28 Whittier Street Portland

Reviewed for Code Compliance
Permitting and Inspections Department
Approved with Conditions

1st Floor Ceiling Beam Kerto-S LVL 1.750" X 16.000" 3-Ply - PASSED

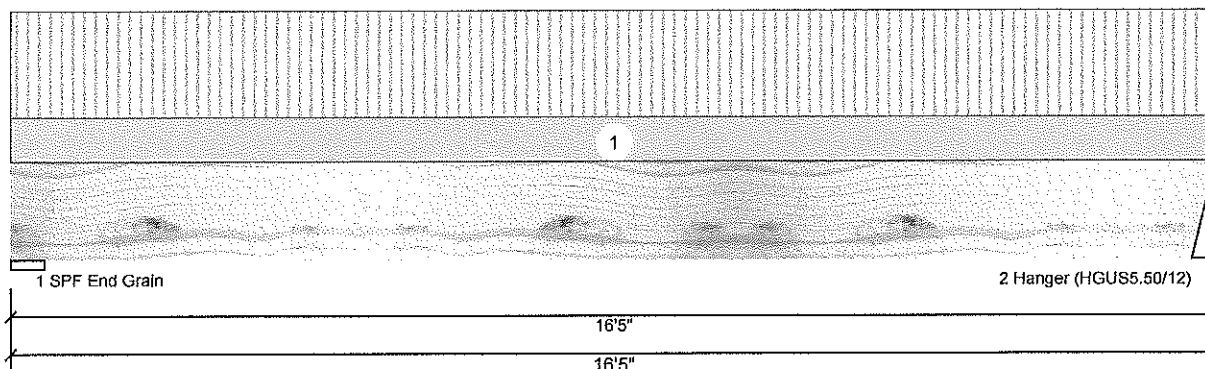
Your drawings seem to show you are removing an existing bearing wall between the kitchen and dining room and replace that bearing wall with a new manufactured beam.

I need to know the design loading (uniform and point loads) and the approved size of the beam. I also need to know the required post sizes at each end of the beam with approved connections as well as how these new point loads will be carried to the foundation or footings in the basement below.

You can provide me with a structural design report (for this specific installation) from the beam manufacturer or have a local structural engineer stamp the approved design.

Analysis	Actual	Location	Allowed	Capacity	Comb.	Case
Moment	31359 ft-lb	8'3 1/4"	53922 ft-lb	0.582 (58%)	D+L	L
Unbraced	31359 ft-lb	8'3 1/4"	31477 ft-lb	0.996 (100%)	D+L	L
Shear	6609 lb	1'8 5/8"	17920 lb	0.369 (37%)	D+L	L
LL Defl inch	0.302 (L/627)	8'3 5/16"	0.526 (L/360)	0.570 (57%)	L	L
TL Defl inch	0.435 (L/435)	8'3 5/16"	0.789 (L/240)	0.550 (55%)	D+L	L
